The Fields at Sherborn

Response/submittals/summary for Sherborn Conservation Commission meeting 8/31/15

August 26, 2015 Revised August 27, 2015

Re: **NOI, Washington Street (Map 3 Lots 88B and 88C), Sherborn, MA, DEP file #283-0366**

LAYOUT PLAN
THE FIELDS AT SHERBORN
WASHINGTON STREET
SHERBORN, MA

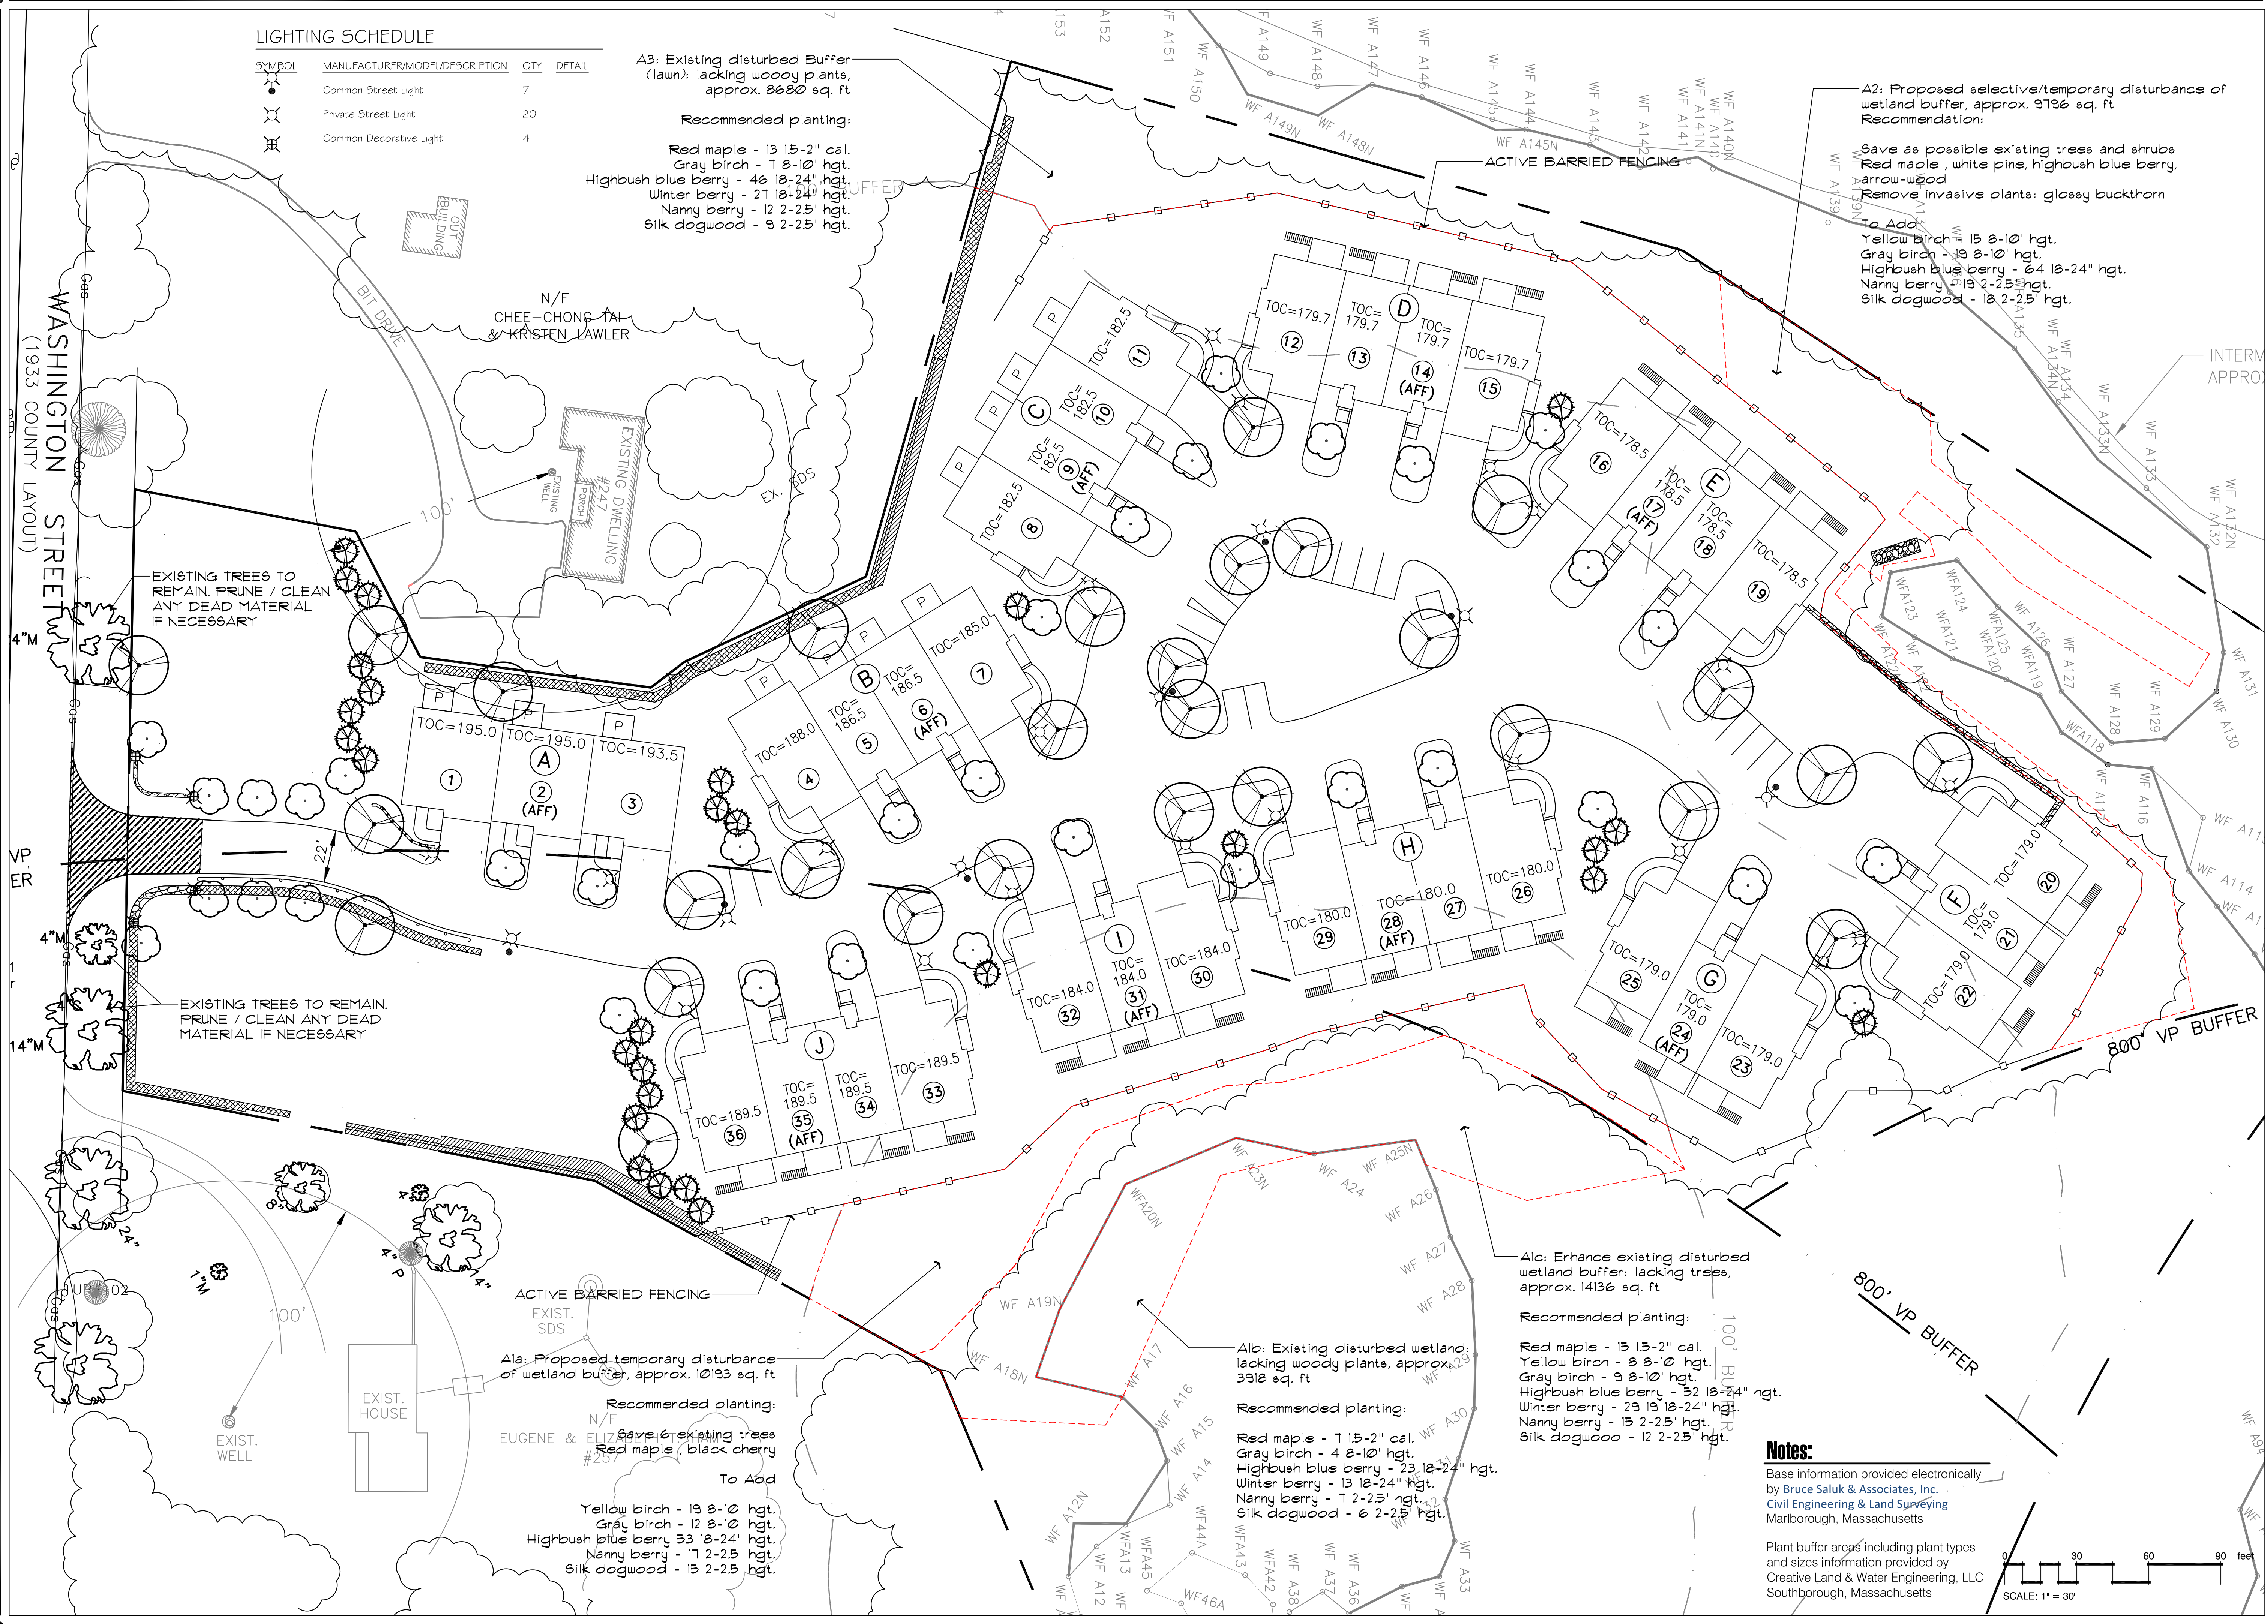
1. Layout Plan (C1) by Bruce Saluk and Associates dated December 8, 2014 with revisions through 7/28/15 (Plan changes are added "activity barrier" and snow storage areas) plan is pending some minor updates for cultic drainage system.

Sheet: **L1**

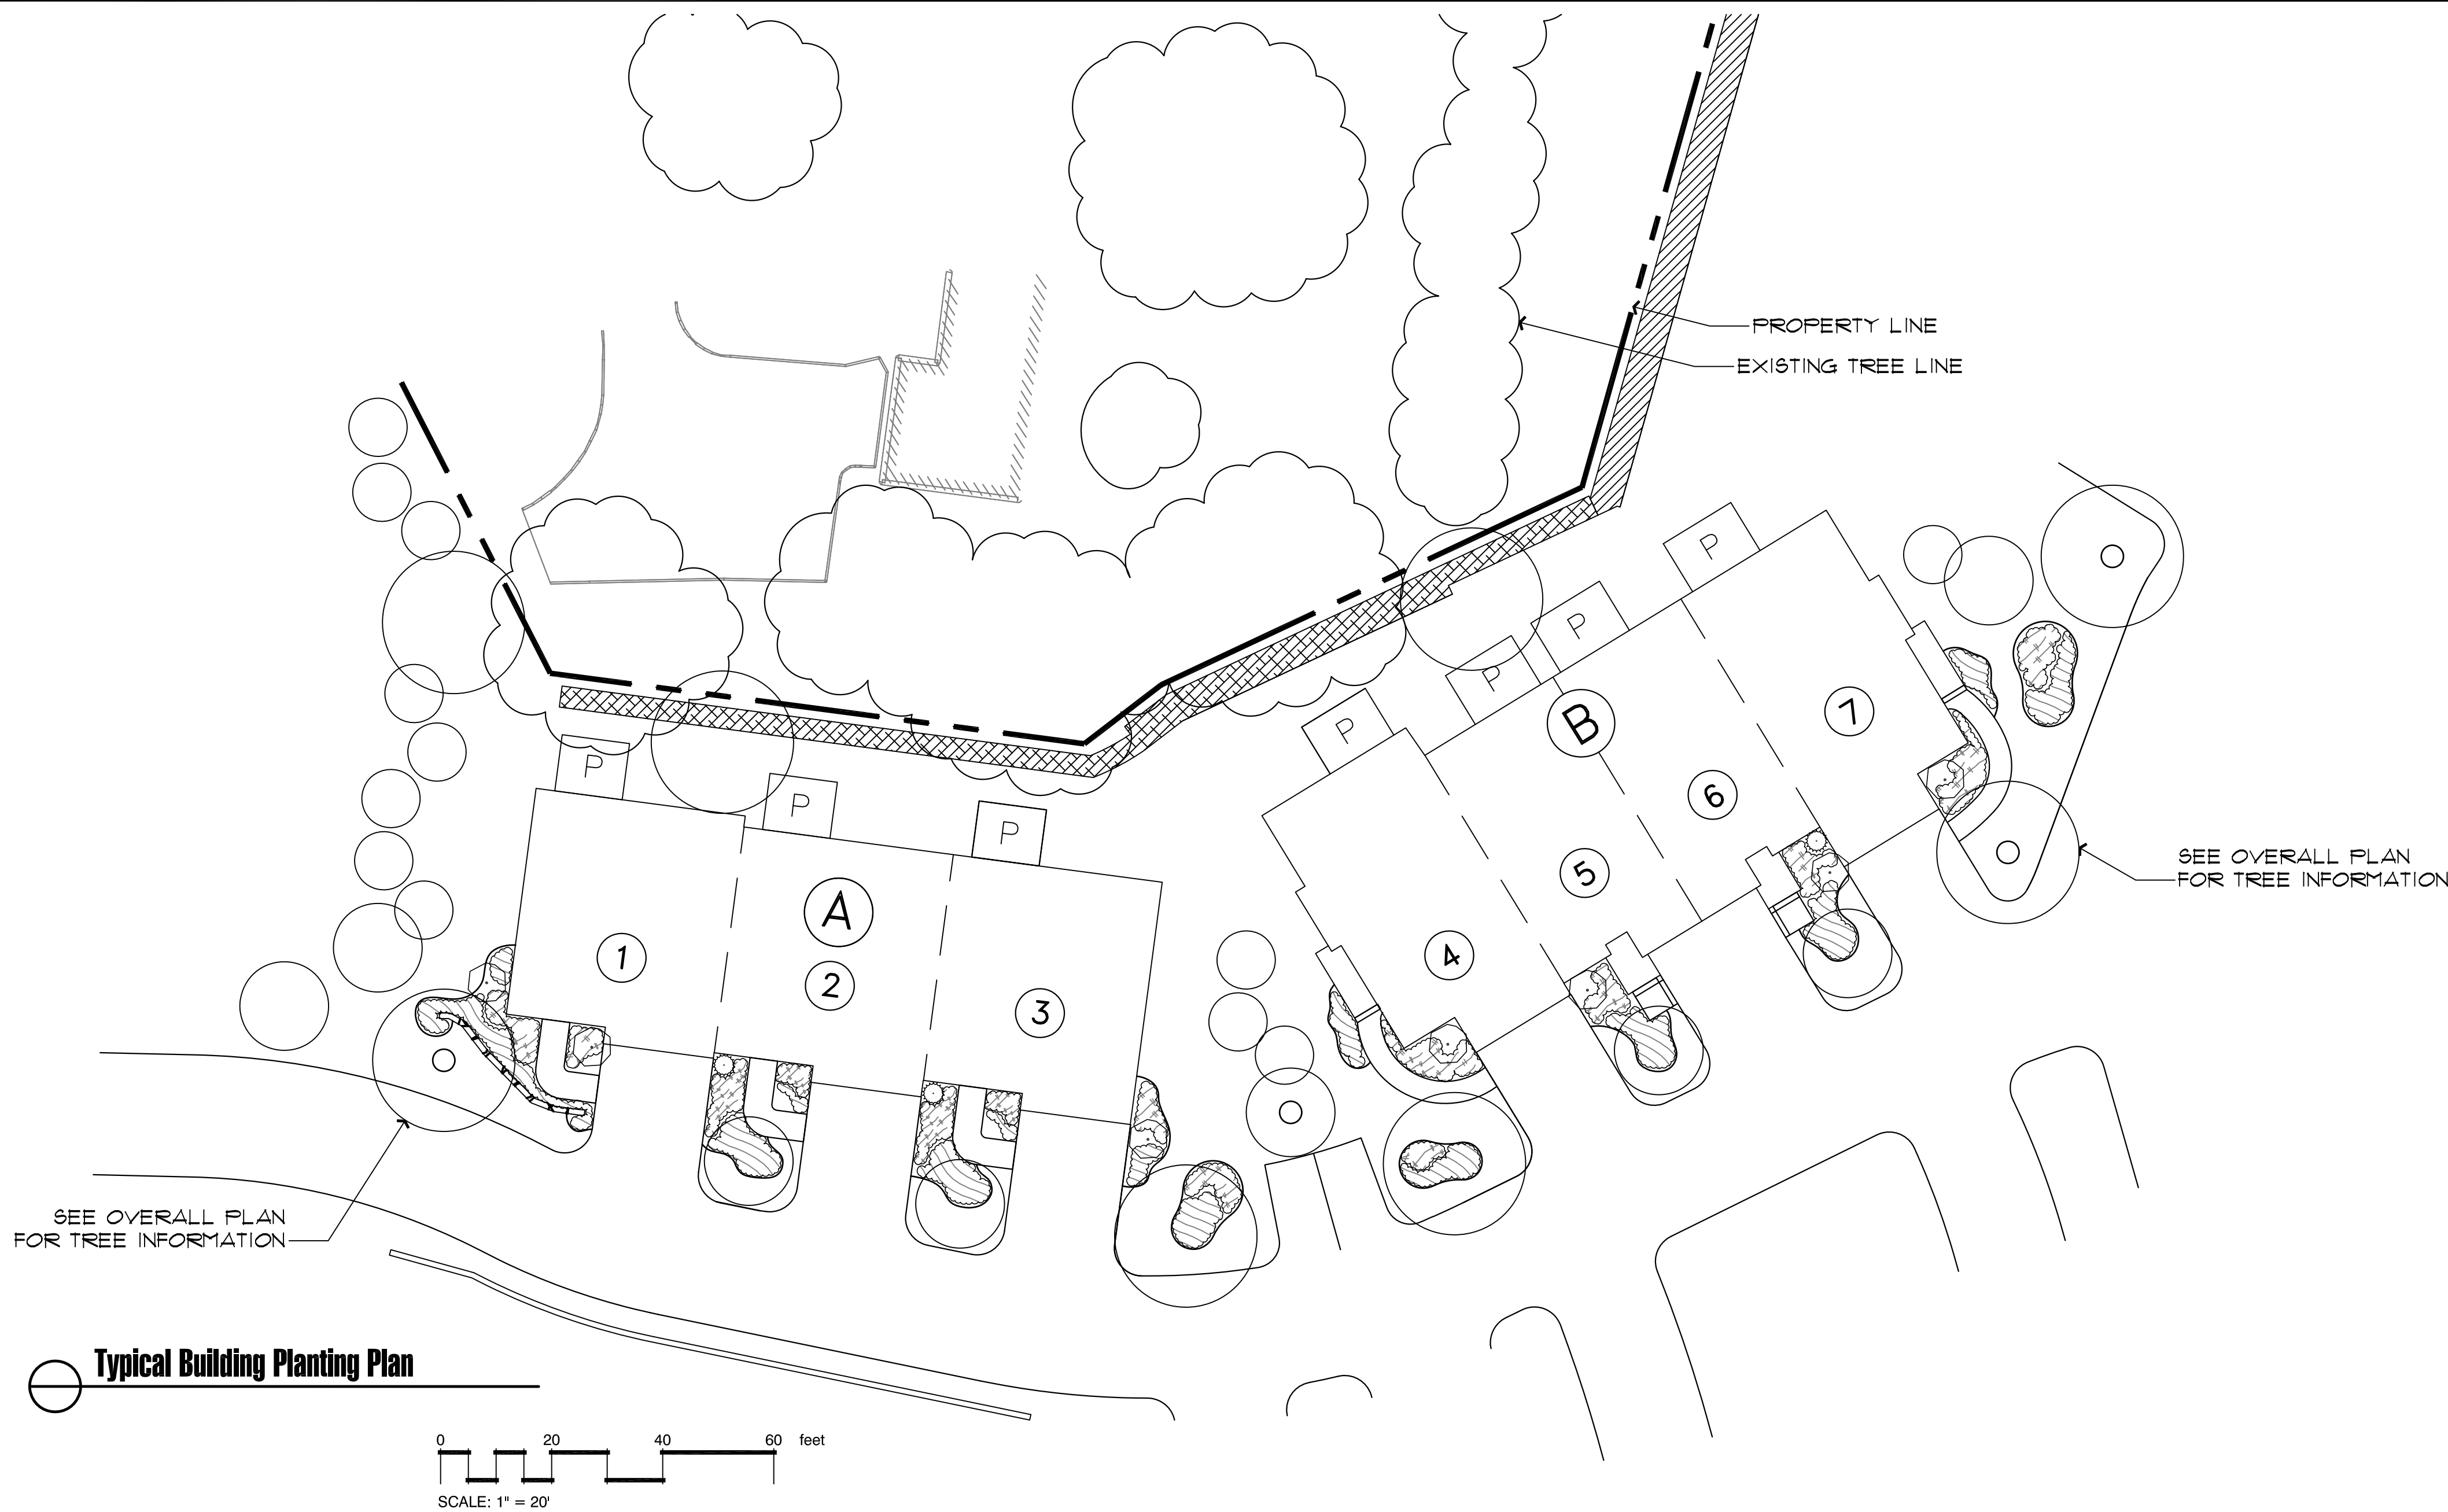
2. Landscape Plans L1, L2, L3 by Hawk Design dated 8/27/15.
 - a. **L1 plan** details overall landscaping, along with detailed planting area in proposed mitigation/restoration areas, per CLAWÉ plan attached.
